CITY OF FORT PIERCE

Agenda Item 7A

HISTORIC PRESERVATION BOARD : PUBLIC HEARING

Replacement of existing metal shingle roof with 5V crimp metal panel roofing & removal of original chimney.

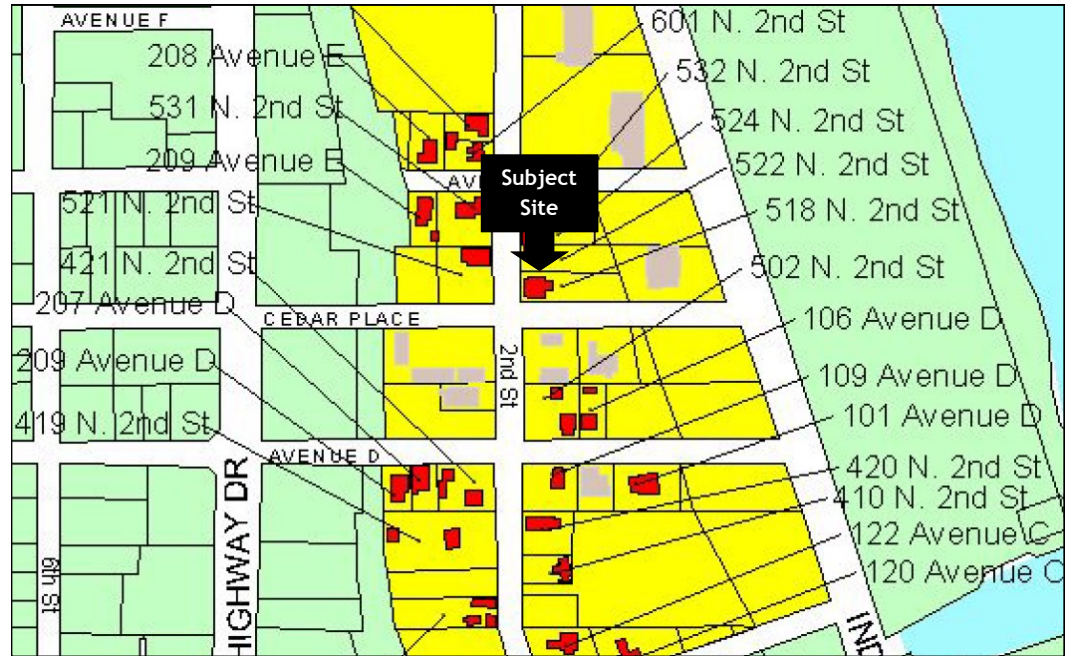
The metal shingle roof present on the structure appears to be in fair to good condition. The applicants have expressed concern regarding minor leaks and water intrusion, and have selected to seek the replacement of the roof. The applicant has submitted cost estimates from various contractors, presenting the cost differential between a metal shingle roof and 5V Crimp metal panel roof. The presented figures indicate the approximate cost of a direct replacement at \$25,860, while replacement with the proposed 5V Crimp Metal Panel roof is closer to \$12,860. A cost estimate to repair and reseal the existing metal shingles was not provided by the applicants, however Staff is pursuing estimates for presentation to the applicants, and to the Board at the meeting. It is noted that the rear addition, completed after initial construction of the home, features 5-V crimp roof panels. This current differential is not of design concern as the views of this addition are limited, and it arguably assists in the delineation as a later addition.

The original chimney present on the structure contributes to the historical nature of the structure, and overall design scheme. Although the chimney is presently “non-functional” based upon the interior floor plan and function of the present owner, functionality may be re-established in the future. The chimney may be easily sealed and should be preserved for design compliments and potential use in the future.

The request to replace the existing metal shingle roof with 5V Crimp Metal Panels, and the removal of the original chimney would eliminate distinctive finishes, and examples of craftsmanship that characterize a property, and alters the design of the roof, presenting conflict with Secretary of Interior Standards 5 & 6, therefore staff recommends that the Board condition the COA request upon the repair, sealing, and minor replacement of existing metal shingles of the existing roof, or the utilization of metal shingles for a complete reroof, and deny the request to eliminate the existing chimney.

Roof Replacement:
Approval with conditions

Chimney Removal:
Denial
